Architectural Commission Report

Subject: **WALDORF ASTORIA (PL1630568)**
9850 Wilshire Boulevard

Request for approval of a new gateway statement located at the intersection of Wilshire Boulevard and Santa Monica Boulevard. The City Council previously certified a Final Environmental Impact Report for the project on April 21, 2008 pursuant to the California Environmental Quality Act, and no further environmental review is required at this time.

**Beverly Hills Gateway
Enlargement**

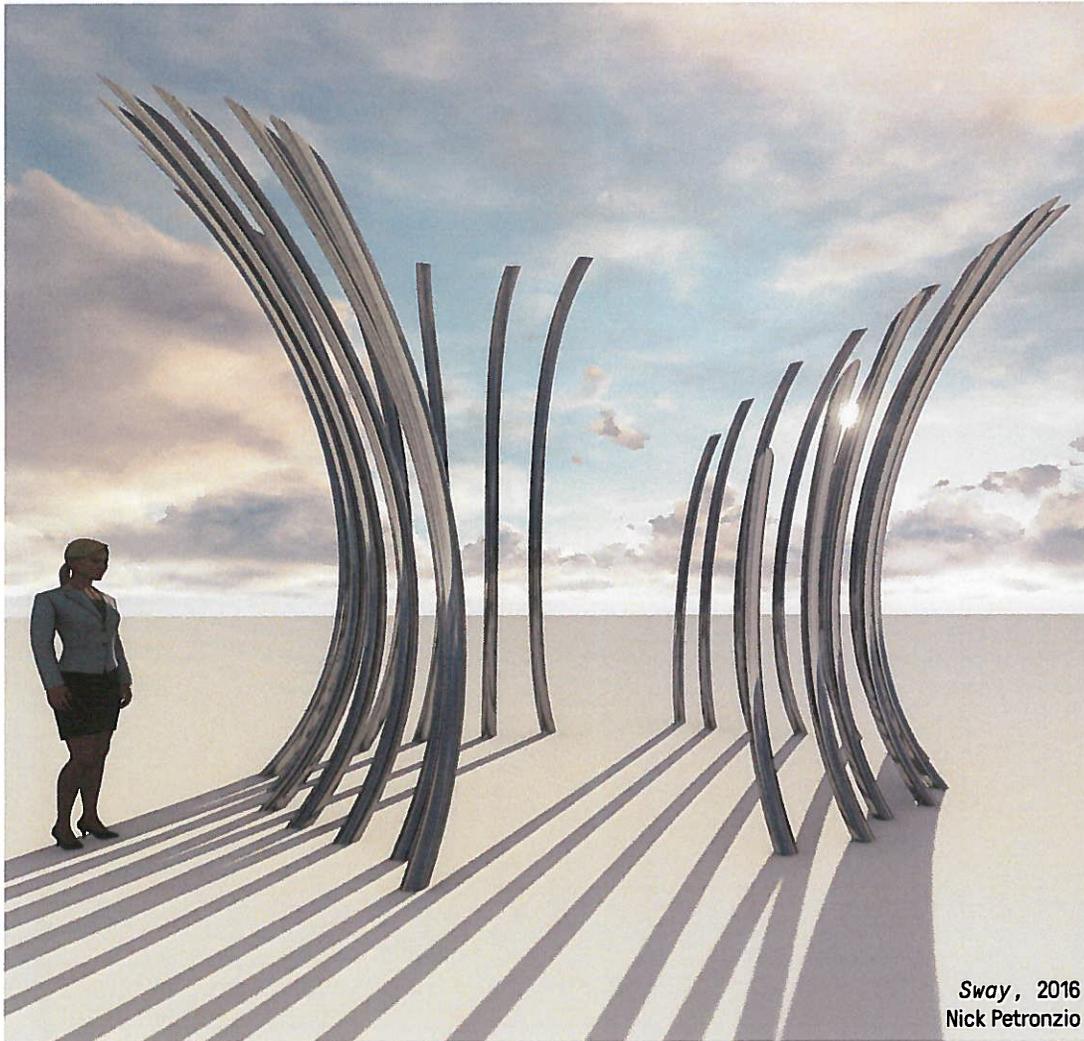
The design team should continue to review the color temperature for the proposed sculptural accent lighting to ensure the intensity does not overshadow the light display of the historic electric fountain on the opposing corner. Details should also be provided for the delineation of the sidewalk from the more central area (encompassing the sculpture) identified as decomposed granite.
